N576NAS1

TECHNICAL BULLETIN

Service Action - Coolant Level Sensor Loose

MODEL:	MODEL YEAR:	VIN:
Defender (LE)	2020-2021	000001-025820

E253500

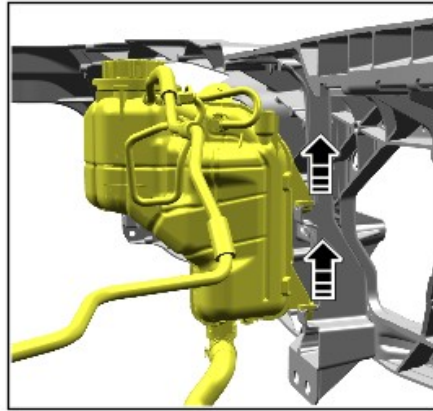
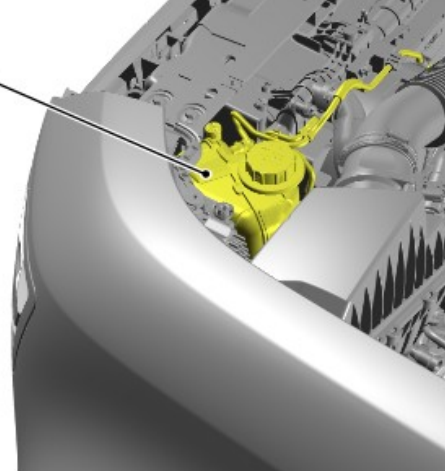
The coolant expansion tank part number is located on the opposite side of the expansion tank to the Min/Max markings.

Release the coolant expansion tank and reposition upwards so the part number is visible.

E283547

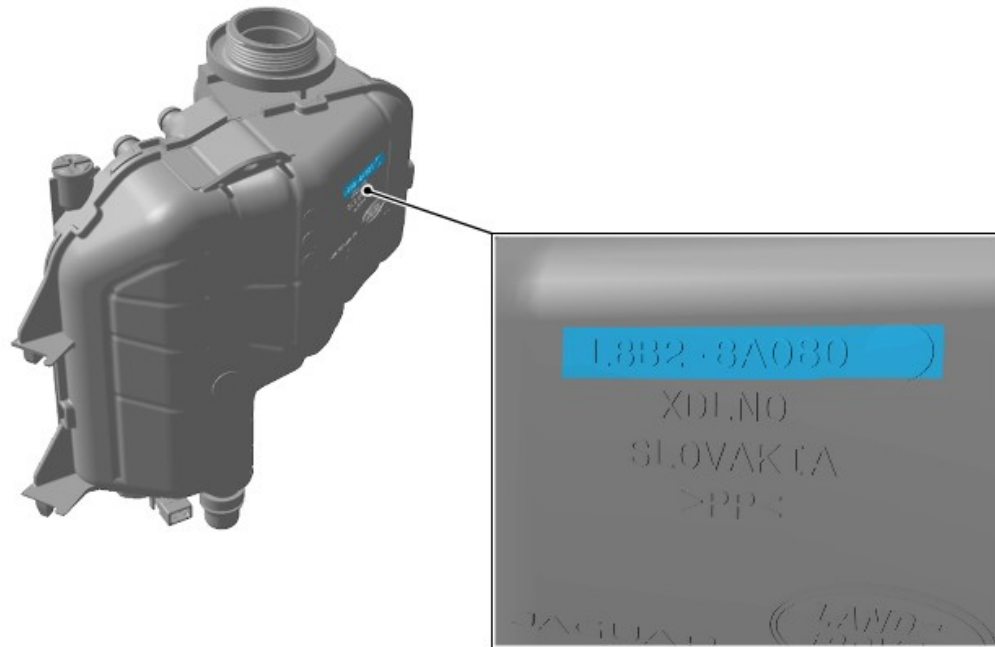
Inspect the coolant expansion tank part number.

- If the coolant expansion tank part number is **L8B2-8A080-AF** or **L8B2-8A080-AG**, reverse steps 1 to 3 and release the vehicle.
- If the coolant expansion tank part number is not **L8B2-8A080-AF** or **L8B2-8A080-AG**, continue to the Service Instruction.
